CONSTRUCTION CHANGE ORDER

PROJECT: Sessom Creek Bank Stabilization and WW Replacement - Phase 2
CONTRACT NO.: 224-002

Date Prepared: 9/5/2025
Change Order #: 4

Re: Sessom Creek Bank Stabilization & Wastewater Replacement – CO #4

ABANDONMENT PLAN

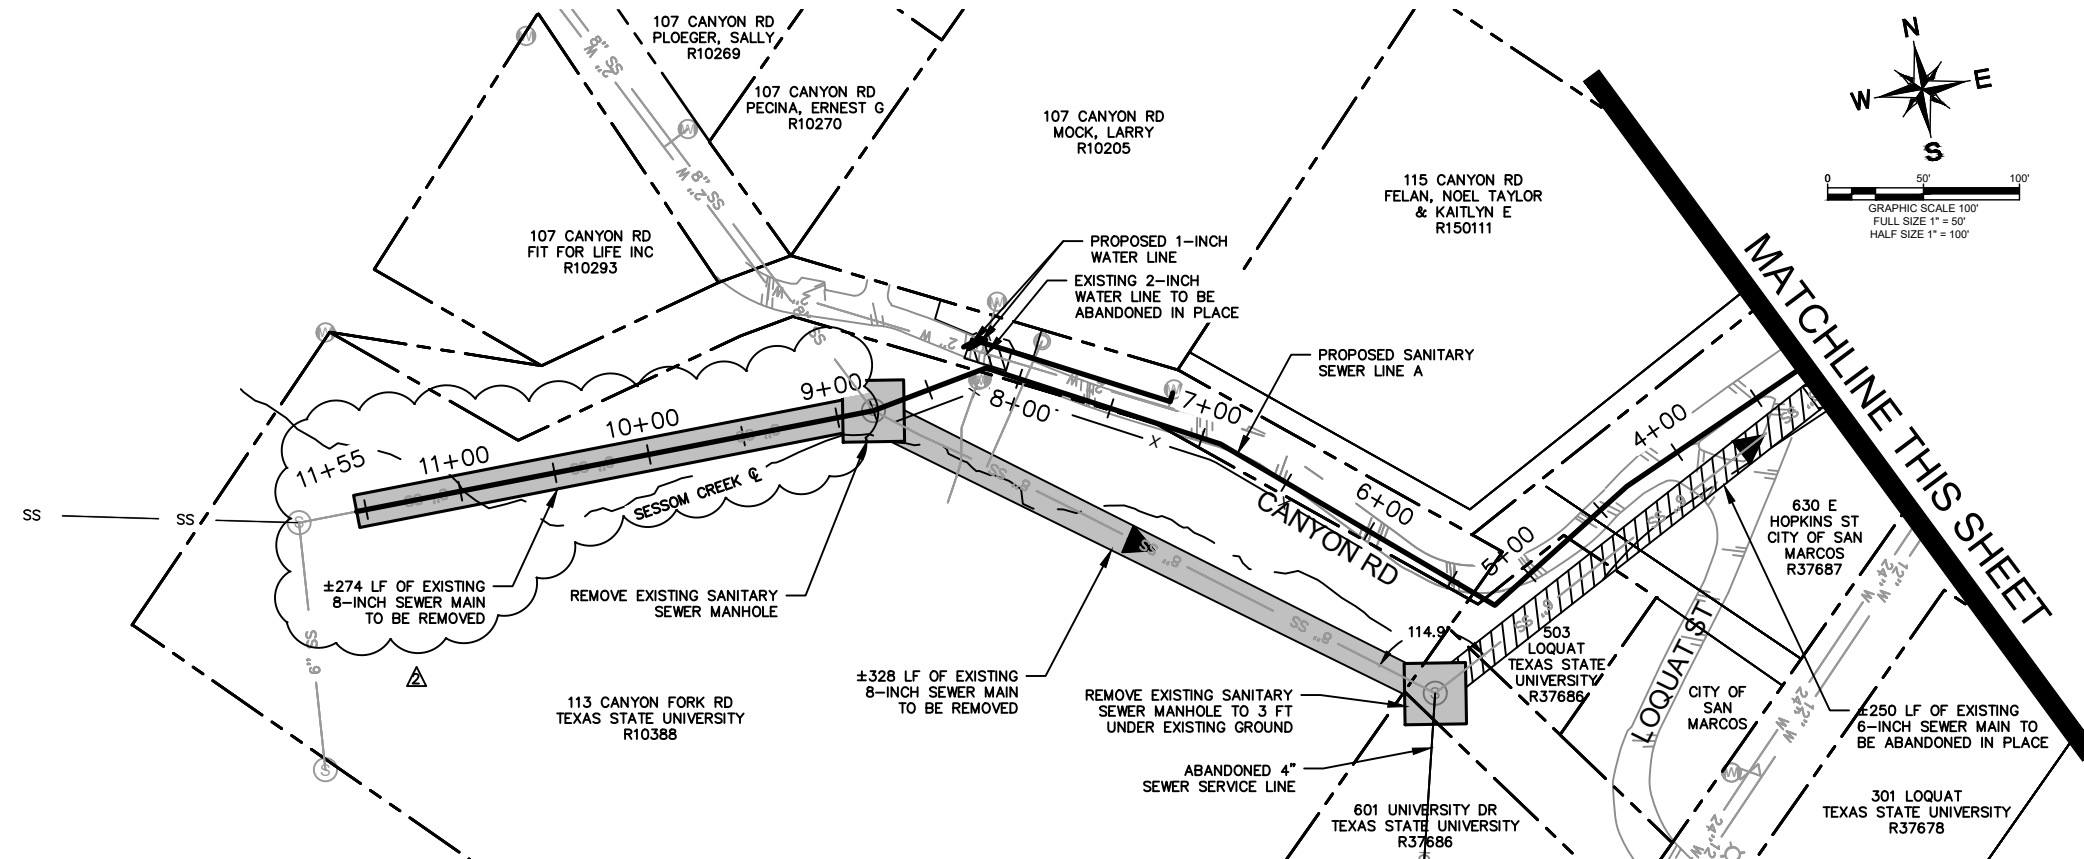
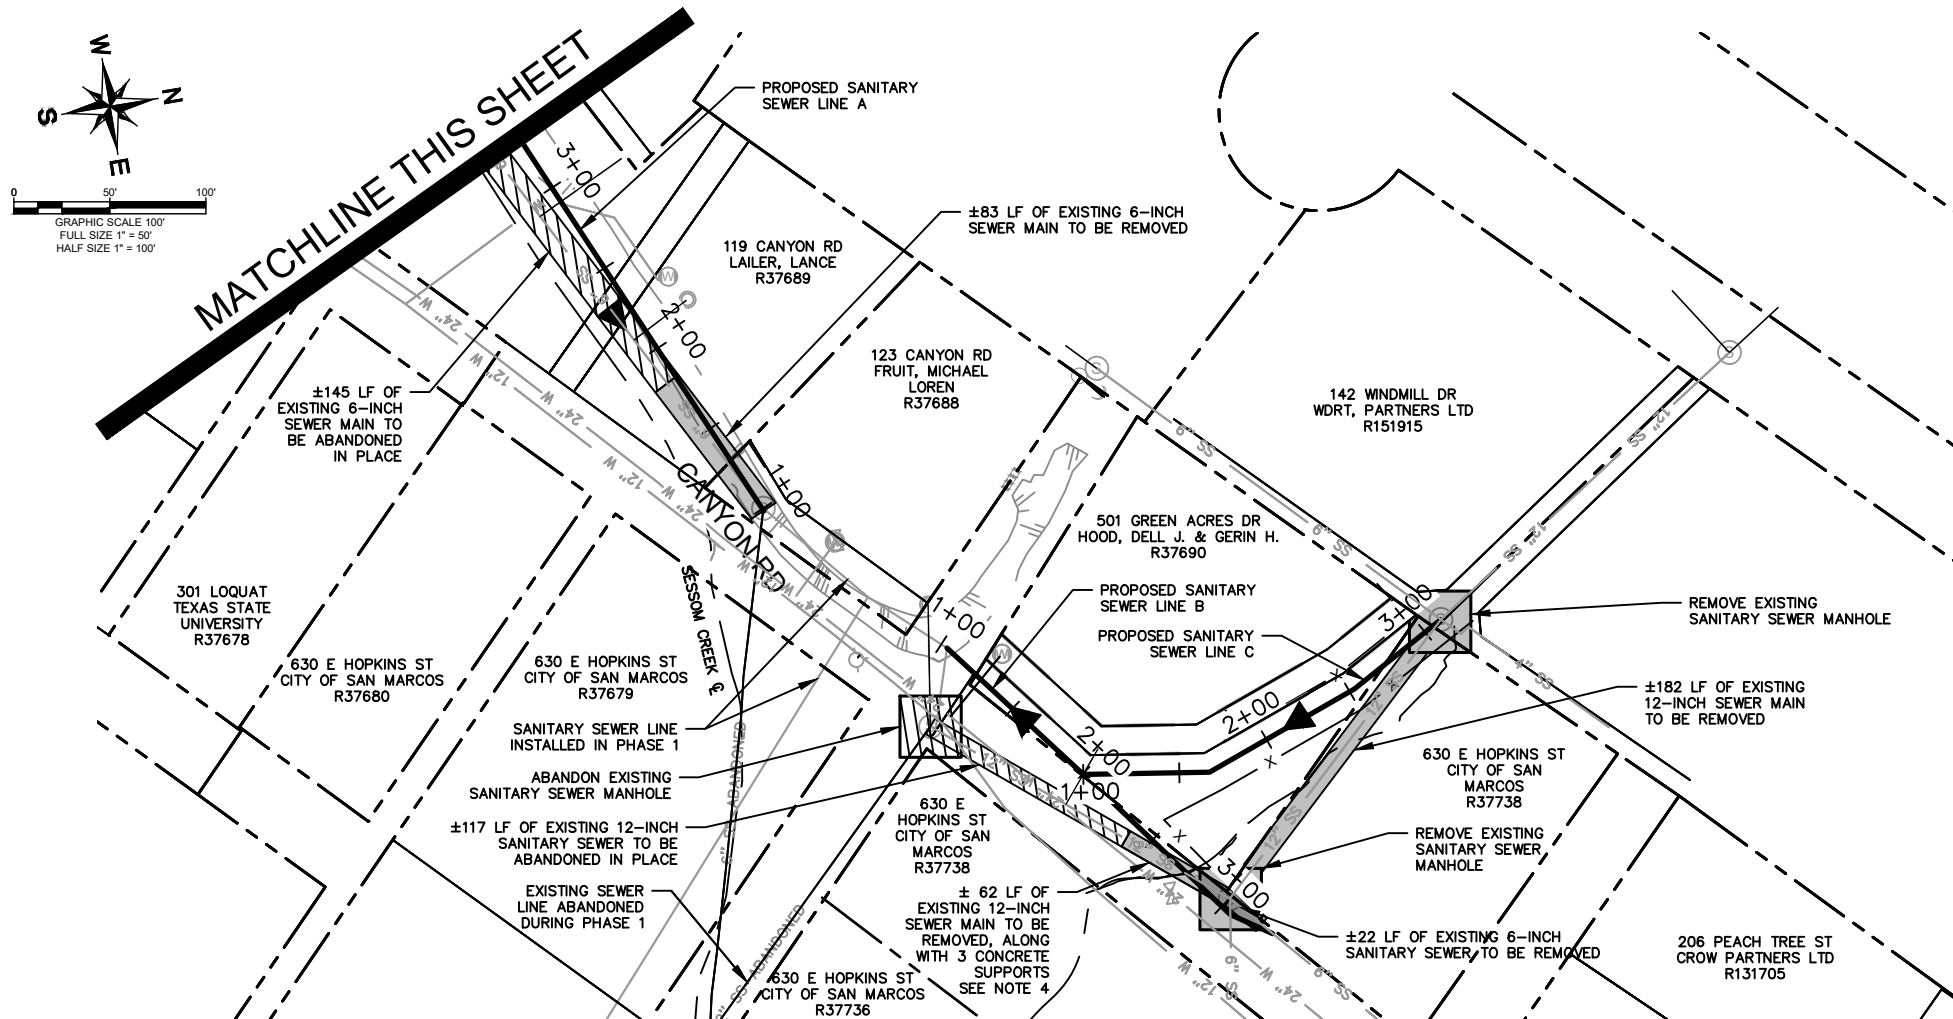
No.	Revision	By	Date
2	RFI 14 REVISIONS	CRW	9/25

SANITARY SEWER PLAN &
PROFILE LINE A STA.
4+00 TO 8+00

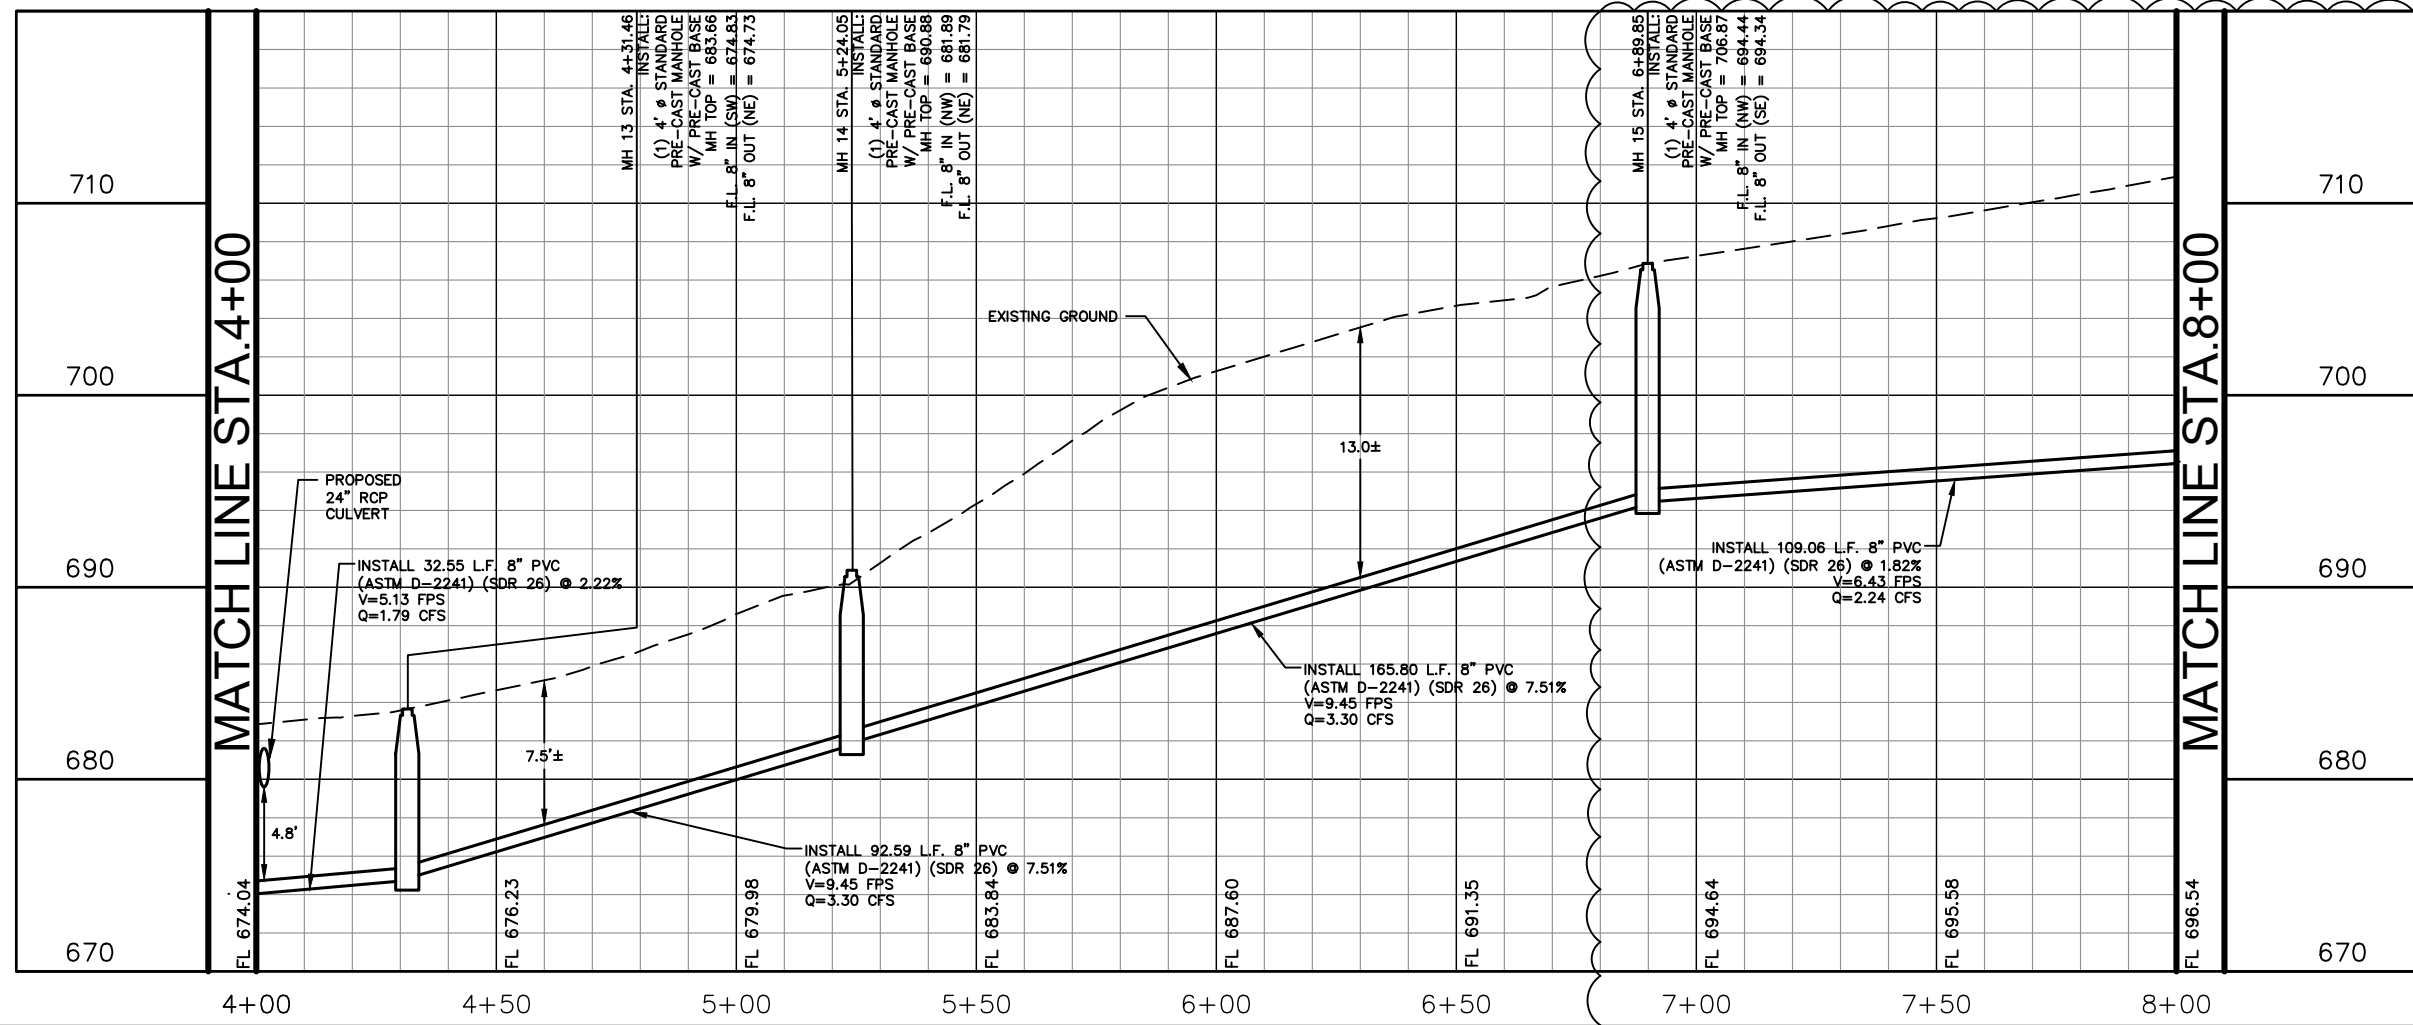
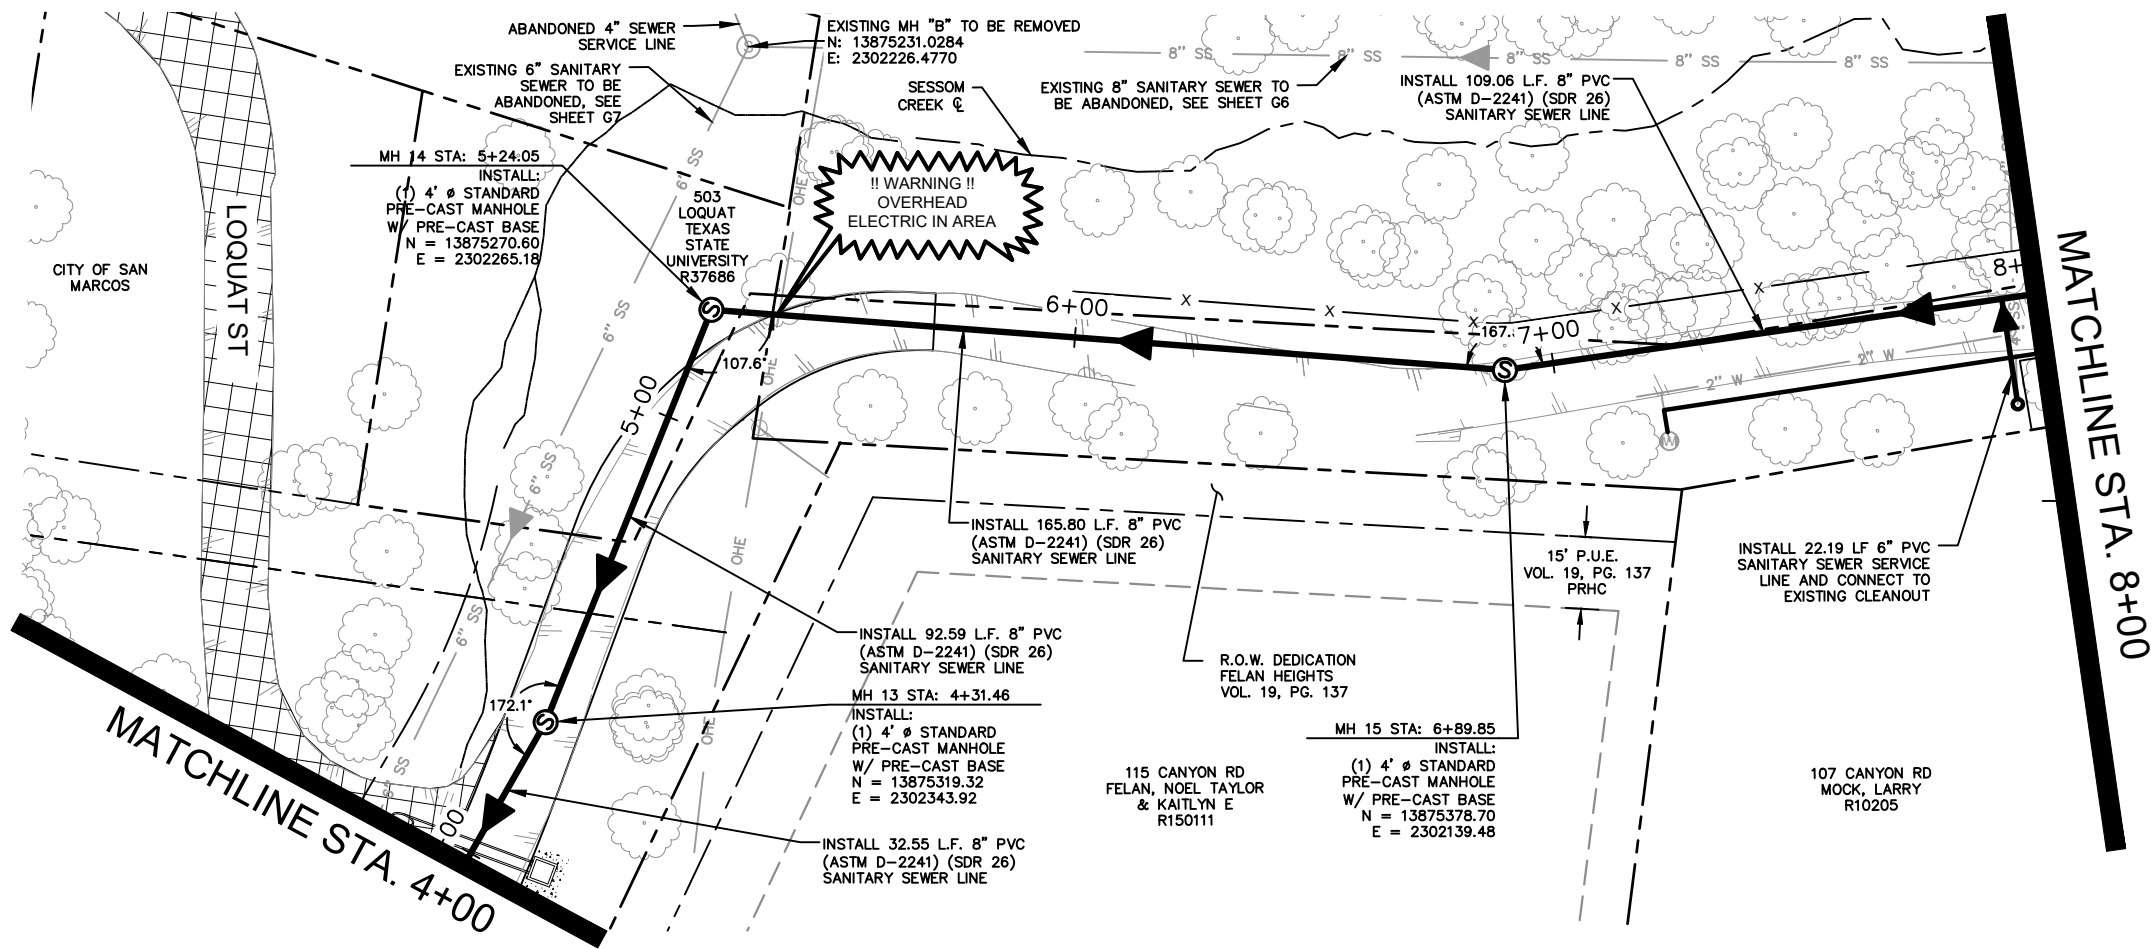
Corresponding quantity adjustments per RFI 14a:
Additional WW Replacement = Remove exposed wastewater line upstream of MH 17 and replace with new WW line & appurtenances
Additional Roadway Repair = Full road repair up to the concrete driveway of 107 Canyon Rd to better coincide with limits of W/WW replacement
Revised water services = 1" blue poly (in lieu of 2" PVC) per COSM Public Works preference
Revised tree protection (additional tree removal & corresponding mitigation measures), erosion control, and quantity sheets to correspond with the plan revisions noted above
Add 40 Working Days (approx. 2 months) to the Project Schedule (PS-1):
> The Contractor must achieve Substantial Completion within **250 Working Days** after the Project Start Date = Wednesday, May 6, 2026
> The Contractor must achieve Final Completion within **295 Working Days** after the Project Start Date = Monday, July 13, 2026
